STAFF ANALYSIS

CASE NO.:	Z-26-1248023	File ID #: 2026-0708
Address:	2570 McAfee Road, Decatur, GA 30032	Commission District: 3 Super District: 7
Parcel ID(s):	15 170 05 017	
Request:	Application of Jamila Brown to rezone property from R-75 (Residential Medium Lot-75) and Tier 2 of the I-20 Overlay District to C-1 (Local Commercial) zoning district and Tier 2 of the I-20 Overlay District.	
Property Owner(s):	Warren Chancellor	
Applicant/Agent:	Jamilia Brown	
Acreage:	0.609	
Existing Land Use:	Suburban	
Surrounding Properties:	North: C-1 (Local Commercial) South: R-75 (Residential Medium Lot- 75) East: C-1 West: C-1	
Comprehensive Plan:	Suburban	Consistent X Inconsistent

STAFF RECOMMENDATION: APPROVAL WITH CONDITIONS.

Sheet Title: **PROPOSED
SITE PLAN**

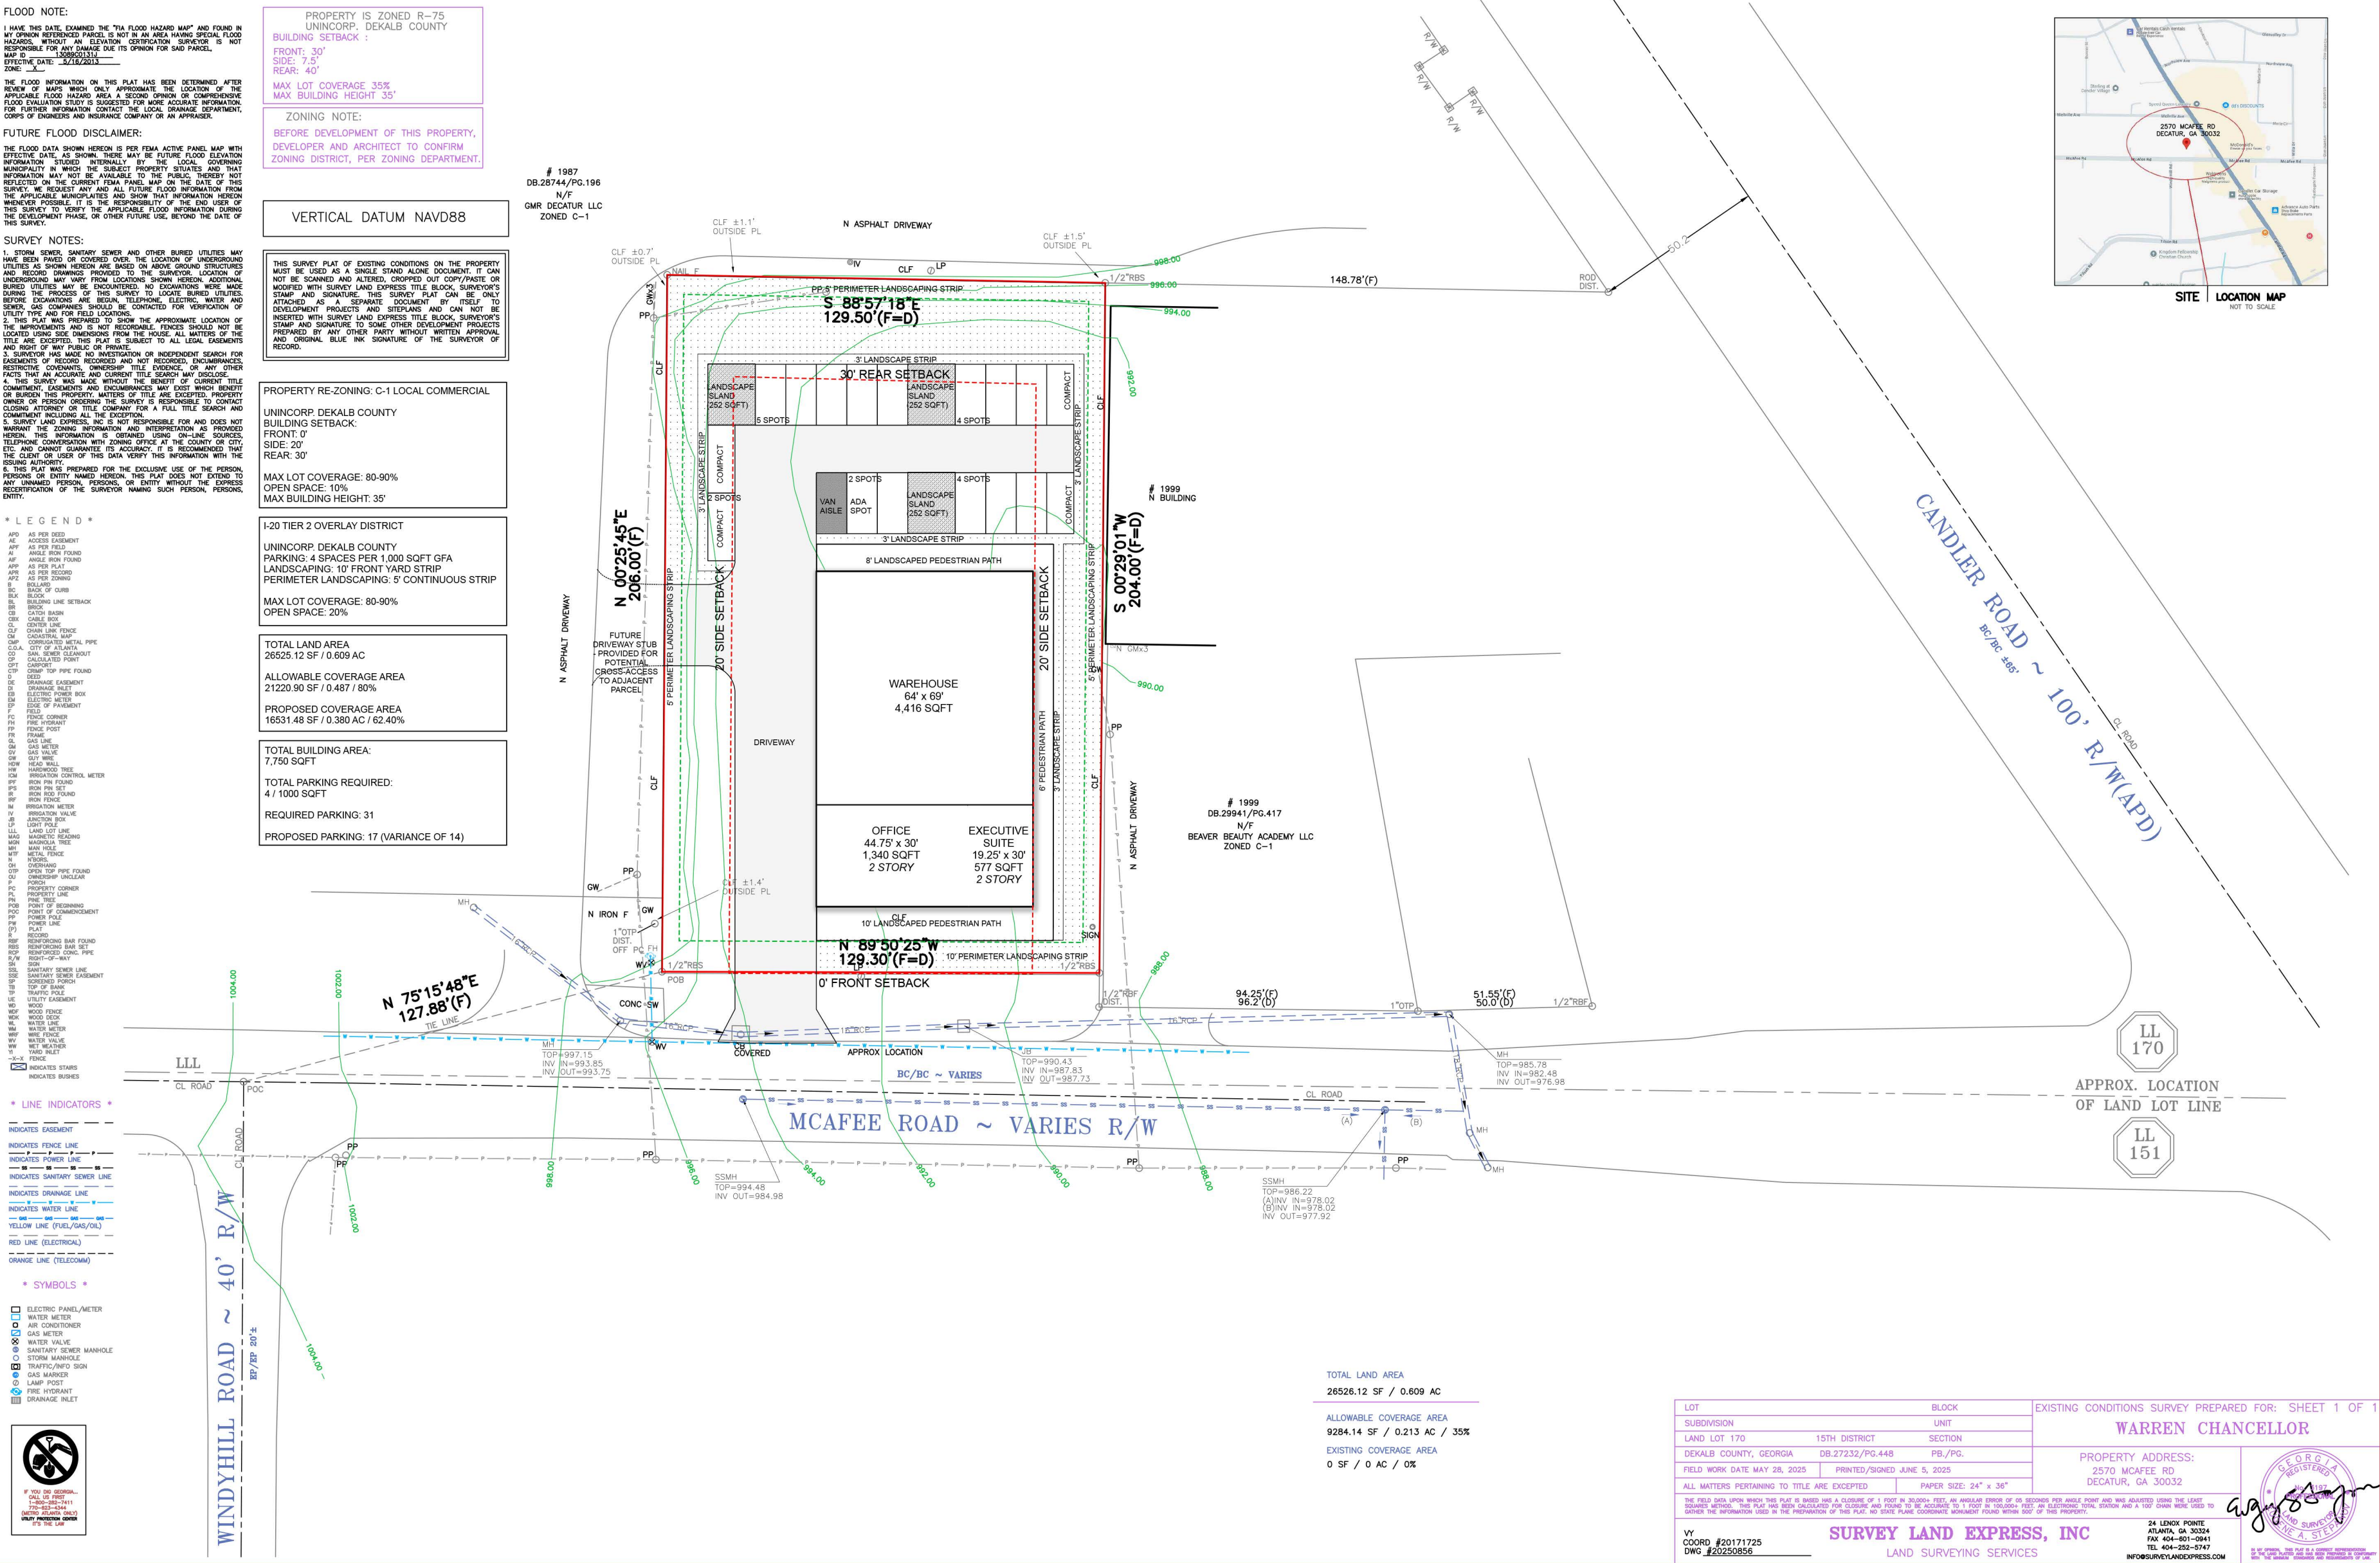
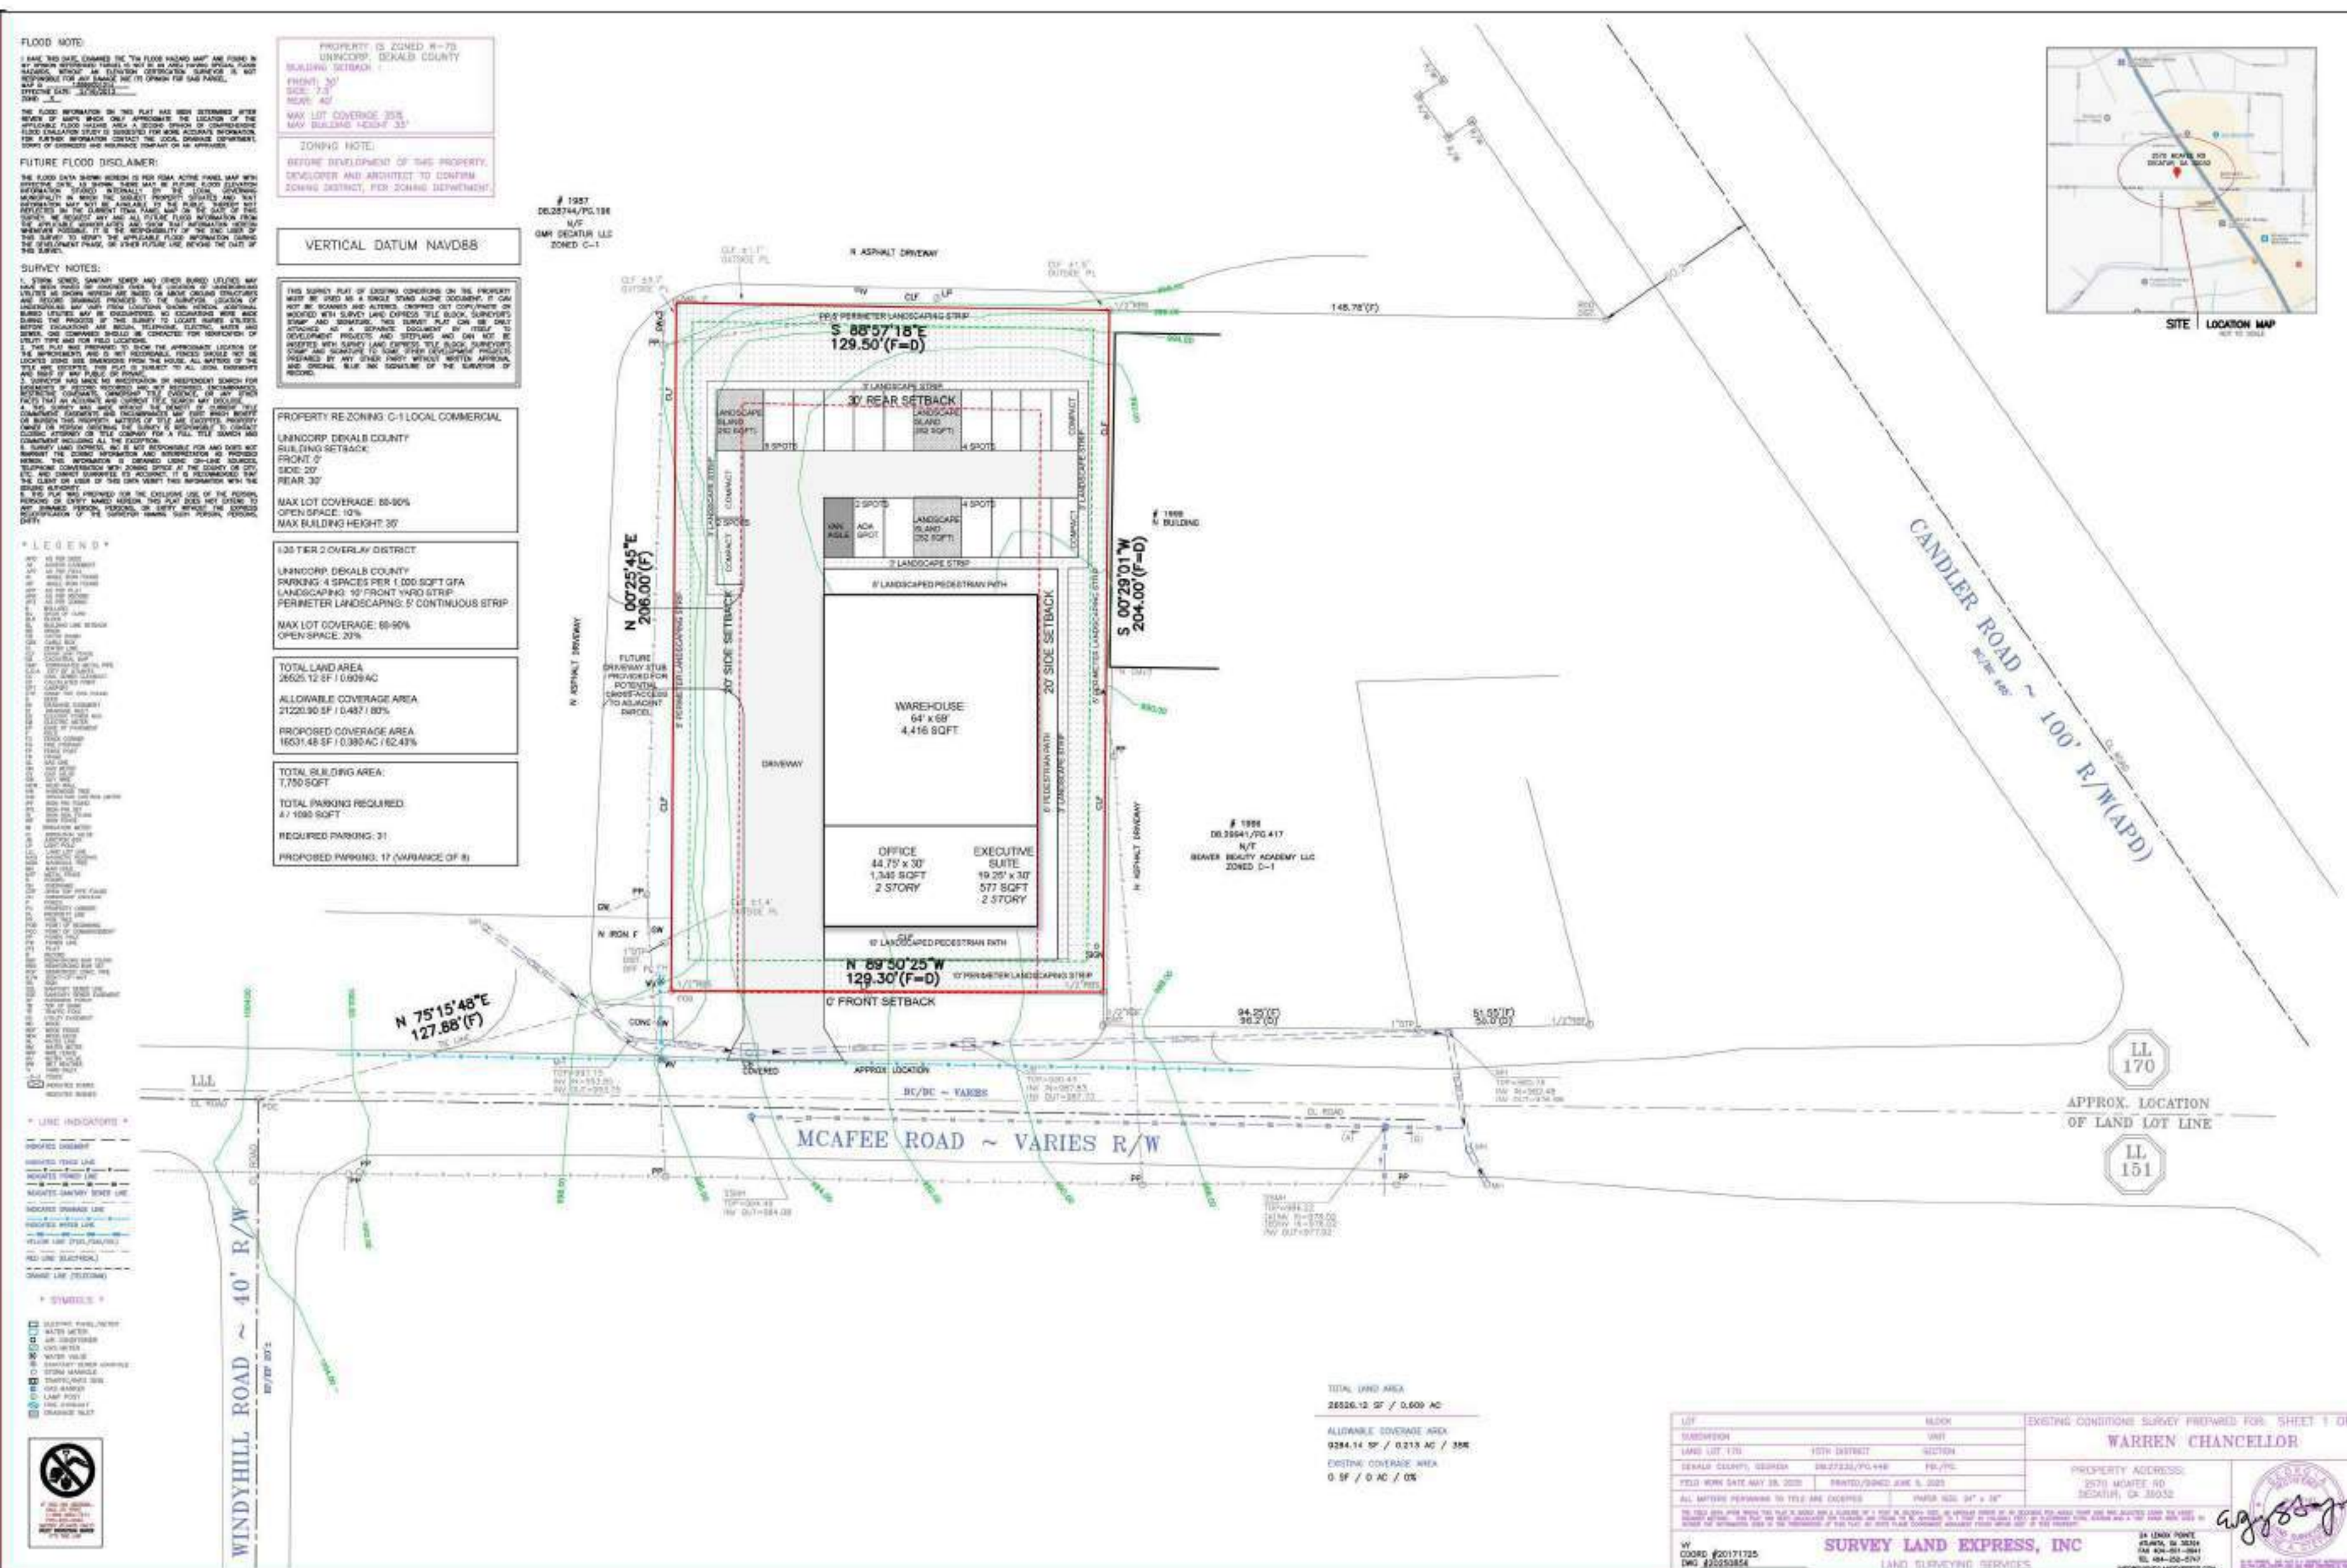
The proposed development generally demonstrates compliance with development standards of the Overlay, including open space requirements (20% minimum per Section 3.33.10), *Office and clinic parking requirements* (3 spaces per 1,000 square feet of gross floor area) per Section 3.33.9, and *Development Standards E2* appear to be met based on the submitted layout. Deficiencies include:

The proposed internal access drive is approximately 14 feet in width- a minimum 24-foot width is required by Chapter 14 (Land Development). This may impact the site's buildable envelope considering the I-20 Overlay development standards, emergency access, two-way circulation, and overall site functionality. The Applicant may reduce and reconfigure landscape islands to accommodate required drive aisle widths and parking standards.

The site plan displays a 10-foot sidewalk, a 5-foot landscape strip, and street trees along the public street frontage, consistent with Section 3.33.14 *A. Sidewalks*. Additionally, the site plan reflects standards of Section 3.33.13 *Landscape strips* requiring 5-foot landscape strips along all sides and rear property lines with a 10-foot landscape strip in front of the building. However, Staff notes this configuration can provide better pedestrian circulation by relocating the pedestrian path along the building edge from the northern building line to the southern building line. The southern building line provides a direct connection from the public sidewalk to building entrances, and internal parking areas.

Pursuant to Chapter 27, Zoning, Article 3, Overlay District Regulations, Section 3.33.12, Architecture Regulations of the I-20 Corridor Overlay District, and Section 3.33.19, Sign Regulations, the applicant shall demonstrate compliance with all applicable architectural and signage standards prior to the issuance of any permits. Additionally, stormwater management and dumpster location have not been fully detailed on the submitted plan and will require further coordination during final design review to ensure compliance with applicable development regulations. The side setback is potentially 20 feet with the rooftop terrace (otherwise 10 feet). Depending on the redesign and revisions to the site plan and terrace, the 10-foot side setback may provide flexibility to move the building and pedestrian path along the western building line.

1. The principal use of the property shall be a general office. Any storage area shall remain accessory and subordinate to principal office use.
2. Warehouse distribution, freight transfer, contractor's yard, and similar storage-oriented commercial uses shall be prohibited.
3. No outdoor storage, outdoor display, outdoor staging of equipment or materials, storage containers, trailers, or commercial vehicles associated with the business shall be permitted on the property, except during active loading and unloading operations.
4. All loading, unloading, and storage activities shall occur in the rear of the property.
